**Substantive response of the Local Highway
Authority to a planning consultation received
under The Development Management Order.**

Planning Application Number: 23/01095/CONDIT

Application Address: The Limes Shackerstone Road Congerstone Nuneaton Leicestershire CV13
6LX

Variation of condition 2 and 4 of planning permission 21/00661/FUL. Amendment to allow for an additional access to serve plot 1.

Figure 1

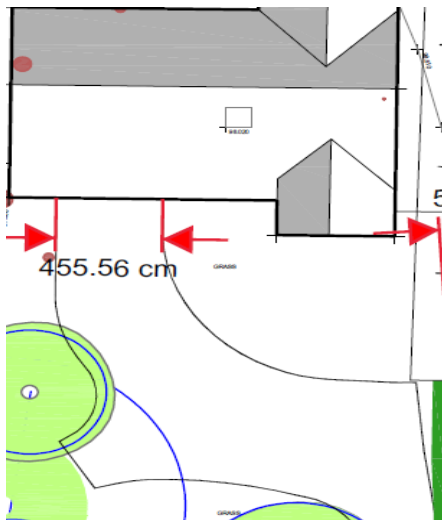
Plot 1

The LHA have taken into consideration that the garages associated with plot 1 do not comply with Paragraph 3.200 of Part 3 of the Leicestershire Highway Design Guide (LHDG), a copy of which can be found at:

Given the above, the Applicant needs to ensure there is adequate provision for three vehicles as per Paragraph 3.151 of Part 3 of the LHDG within the front courtyard. These should comply with Paragraph 3.165 of Part 3 of the LHDG in terms of dimension. This states that the minimum parking size 2.4m x 5.5m should be provided, add 0.5m if bounded by a wall, fence, hedge, line of trees or other similar obstructions on 1 side, 1m if bounded on both sides. As demonstrated within figure 1 below, there is not adequate width provided within the front courtyard to facilitate side by side parking, as such this would limit space within the site to provide adequate on-site turning in accordance with Figure DG13 of Part 3 of the LHDG.

The Applicant should therefore provide vehicle swept path analysis demonstrating turning within the site can be achieved, or a revised scaled drawing demonstrating adequate space for both the quantum of vehicles and turning. The above is required given the proposals are onto a classified C road subject to a 30mph speed limit. The site also appears to be on the most direct route to the village primary school approximately 290m to the northwest of the site. As such, the LHA consider turning within the site should be provided in accordance with Figure DG13 of Part 3 of the LHDG. This is to ensure vehicles can access and egress the site in a forward gear in the interest of highway safety for all users in accordance to Paragraphs 110 and 111 of the National Planning Policy Framework (NPPF) 2023.
